# UNITED STATES PATENT AND TRADEMARK OFFICE

10/705,899

<b>Office Action Summary</b>	<b>Application No.</b> 10/705,899	<b>Applicant(s)</b> LEE ET AL.	
	<b>Examiner</b> HOAN C. NGUYEN	<b>Art Unit</b> 2871

## DETAILED ACTION

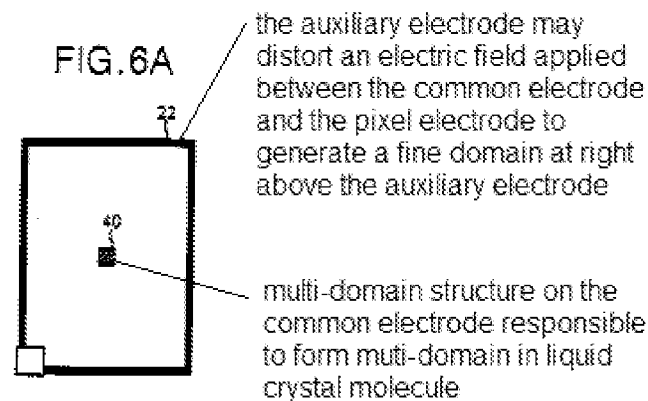
The drawings are objected to under 37 CFR 1.83(a). The drawings must show every feature of the invention specified in the claims. Therefore, the combination of "each pixel region has a multi-domain structure which includes a dielectric structure or slit" and "the common electrode includes an opening area" to form the multi-domain in claim 1 must be shown or the feature(s) canceled from the claim(s). No new matter should be entered.

In the light of the specification, the opening area in the common electrode should form the multi-domain structure. However, although the auxiliary electrode line takes advantage of the gate signal applied to the gate lines, the auxiliary electrode line by itself cannot form the multi-domain without combining with the multi-domain structure (opening) in common electrode. The auxiliary electrode line takes advantage of the gate signal applied to the gate lines would cause the disturbance of liquid crystal molecules because the auxiliary electrode may distort an electric field applied between the common electrode and the pixel electrode to generate a fine domain at right above the auxiliary electrode as shown in Fig. 6A below:

Corrected drawing sheets in compliance with 37 CFR 1.121(d) are required in reply to the Office action to avoid abandonment of the application. Any amended replacement drawing sheet should include all of the figures appearing on the immediate

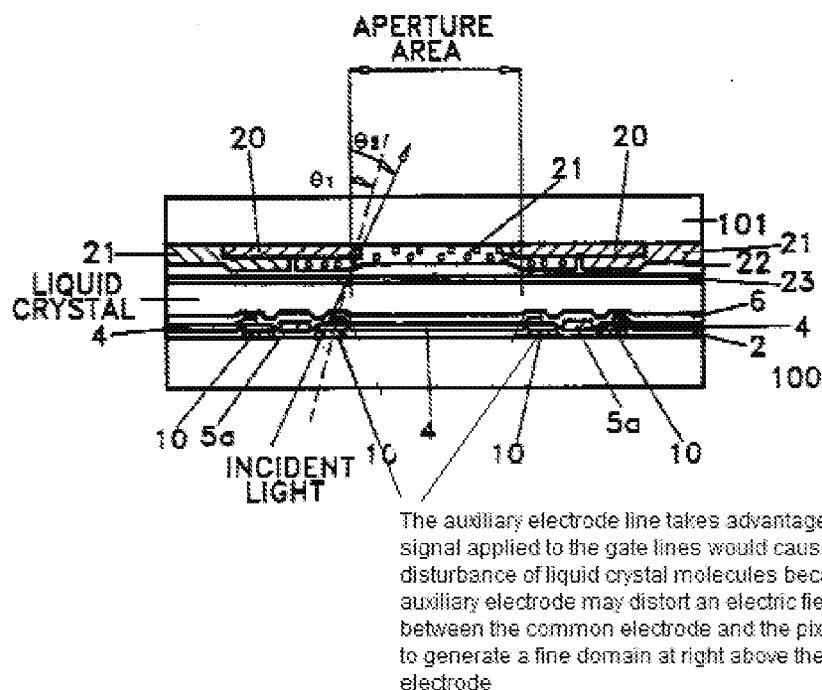
In the same way, the applied reference Kim et al. (US5767926A) discloses the auxiliary electrode line 10 takes advantage of the gate signal applied to the gate lines would cause the disturbance of liquid crystal molecules because the auxiliary electrode may distort an electric field applied between the common electrode and the pixel electrode to generate a fine domain at right above the auxiliary electrode as shown in Fig. 8 below:
